Hi-Fi Products
Service Bulletin

Model: TC-W32

No. 343

Subject: Oscillation in Deck "B"

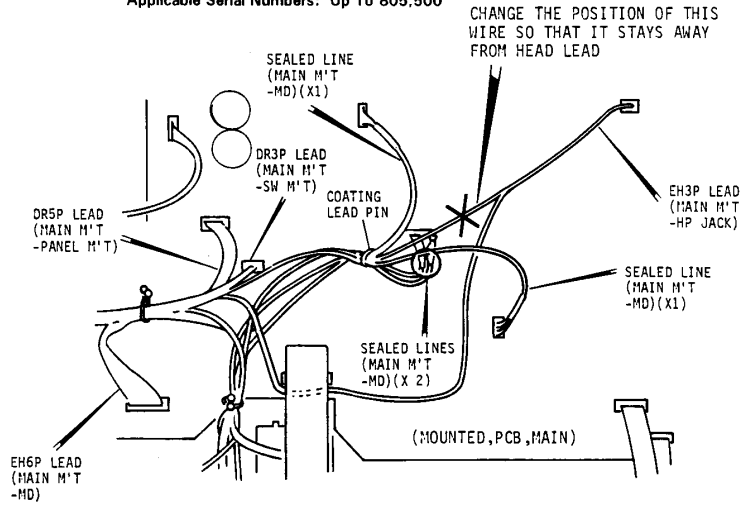
(54) Oscillation occurs on the output of Deck "B" and the level meters peak when playing back certain tapes in the Dolby "C" mode. This occurs on tapes containing a strong signal level (ie. Metal type tapes).

The wire for the Headphone output is positioned too close to the tape deck head wire. Reposition the Headphone output wire so that it is away from the head wire (see layout below for details).
